Our Ref: SS279

5 October 2018

REPORT ON ATTIC BRICKWORK REPAIRS TOWN HALL, FELIXSTOWE

**REPORT ON ATTIC BRICKWORK REPAIRS
TOWN HALL FELIXSTOWE**

LEFT CHIMNEY.

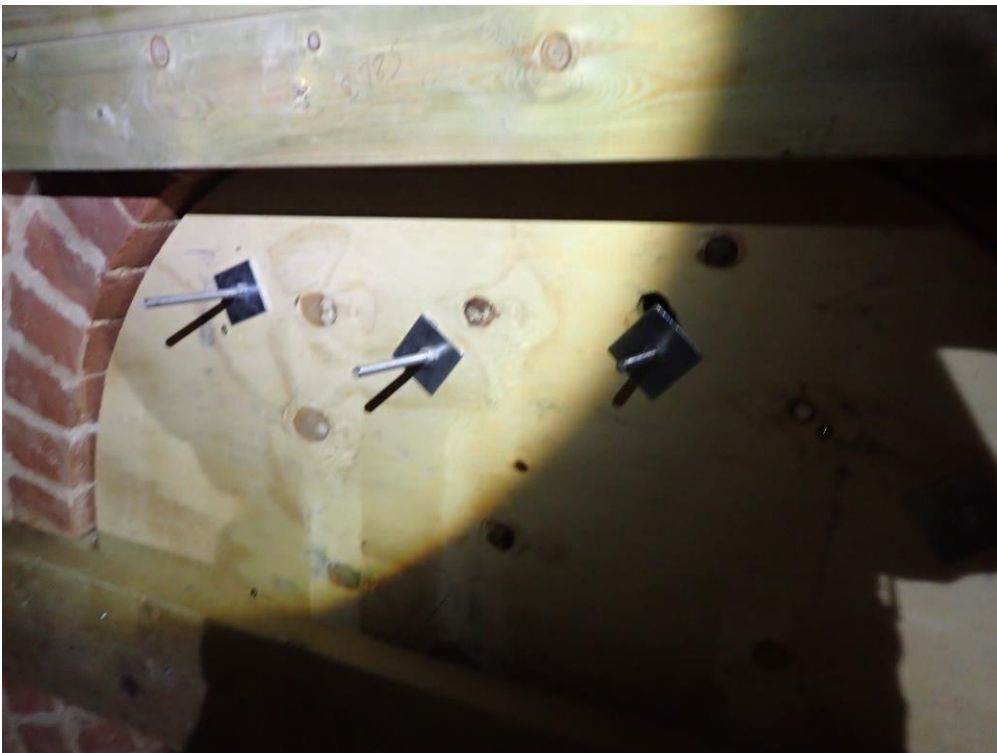
- 3.1.2 The chimney to the left-hand side has been satisfactorily repaired.
- 3.1.3 The right-hand side chimney has had the two levels of Helifix bars installed within the horizontal mortar beds. Brickwork had been replaced where damage and defective mortar beds have been repointed or replaced.
- 3.1.4 In a similar way to the above the three brick courses below the wallplate to the front and front part of the right-hand elevation had been replaced where the brickwork was damaged and repointed where the brickwork was still sound.
